SERVICE BULLETIN

MAIN LANDING GEAR SHOCK STRUT PISTON/AXLE - INSPECTION

REVISION NO. 1 – Feb 26/18

Service Bulletin 49200-32-85 Revision 1 supersedes Service Bulletin 49200-32-85, dated Jul 23/14 and is reissued in its entirety with the changes listed below.

Piston/Axle Inspection - Assembly
Figure 3

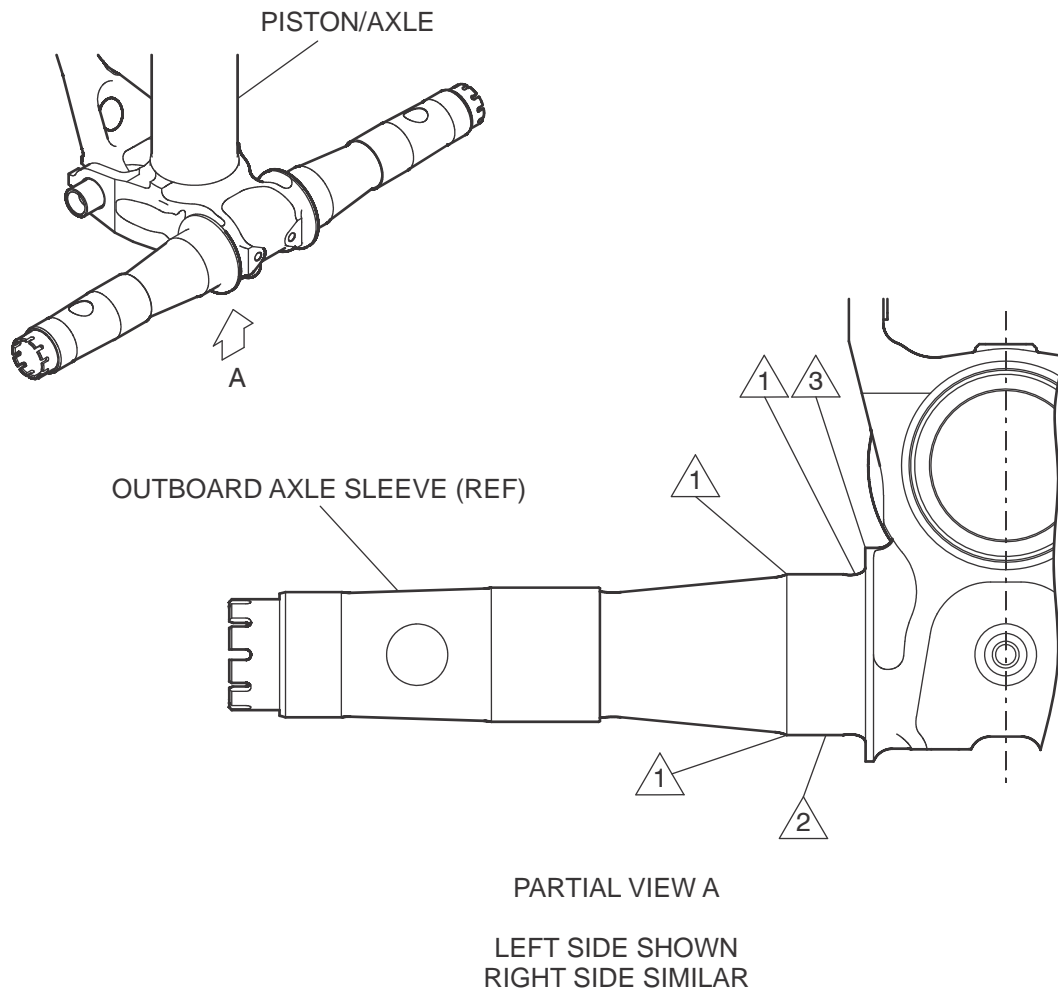
Page/Para	Change
Page 3, Para. 2.B.	CIC added to the list of consumables.
Page 4, Para. D.	Reference for corrosion inhibiting compound revised.
Page 8, Figure 3.	Reference for corrosion inhibiting compound revised

- 1 APPLY A LIBERAL COAT OF CORROSION INHIBITING COMPOUND (CIC) TO ROOT RADIUS AND JOURNAL RADIUS.
- 2 APPLY A LIGHT COAT OF CIC TO AXLE JOURNALS.
- 3 AT ASSEMBLY OF AXLE SLEEVES CHECK FOR CIC SQUEEZE OUT . REMOVE EXCESS CIC WITH A DRY LINT FREE CLOTH.
